**MEETING MATERIALS FOR THE  
METROPOLITAN KING COUNTY COUNCIL**

APPEAL OF A DECISION  
OF A  
HEARING EXAMINER

Proposed ordinance no. **2019-0251**

Preliminary Plat Application of **Gill-Cole**

**Figure 6, SE 200<sup>th</sup> St Eastbound at 138<sup>th</sup> Ave SE (restricted visibility for left turns):**

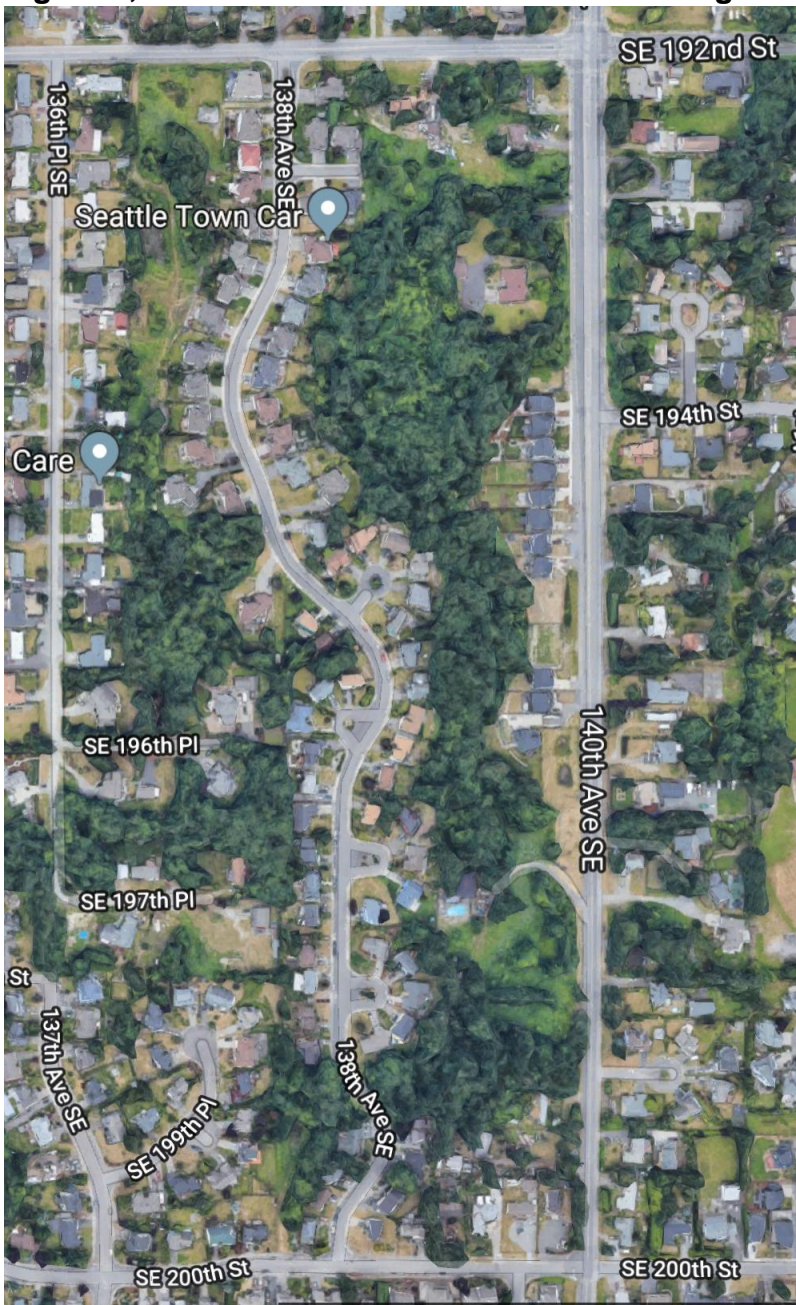
- h. Traffic Study: The traffic study was initiated and concluded on a rainy midday in March. We suggest a new traffic study be completed during commuting times in the morning and afternoon. We suggest the street access from 138<sup>th</sup> Ave SE out onto 192 Ave SE also be studied. 192<sup>nd</sup> AVE SE has become a heavily used roadway. More housing developments to the West and the North will continue to add to the volume. Also not our request for a vehicle count under "Relief Sought" **(See Figure 3)**

- i. The intersection of SE 192<sup>nd</sup> St and 138<sup>th</sup> Ave SE is a bus stop for 2 nearby schools. There is a likelihood for back-ups on SE 192<sup>nd</sup> St and 138<sup>th</sup> Ave SE. This will also be a life and safety issue due to added traffic from Gill Cole Plat co- mingling with children walking to the bus and waiting for it to arrive. **(See Figure 4)**
